Examination of the North Hertfordshire Local Plan 2011 - 2031

Response to Further Matters, Issues and Questions from the Baldock, Bygrave and Clothall Planning Group

Matter 25 – new land proposed for allocation through the main modifications

This further submission supplements our representations on **MM387 (extension of Site BA3 north-eastwards and amendment to boundaries of Sites BA3 and BA4)**. [Representation ID: 6925]

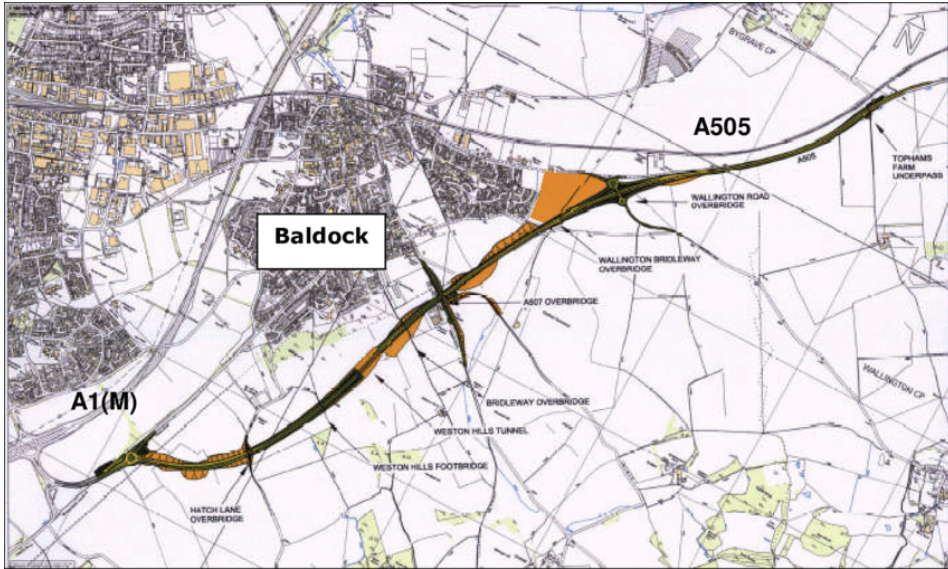
⁴⁰The area of BA3 referred to here is illustrated in Figure 7, and includes the slopes rising up to the raised land.

View from north end of Aleyn Way towards the raised ground immediately to the east, illustrating how the land rises quite steeply (as a result of which, development on this raised area would not be sympathetic to the landscape setting and would be likely to have an overbearing effect on houses in Aleyn Way and Merchants Walk). Image © WYG for Hertfordshire County Council.
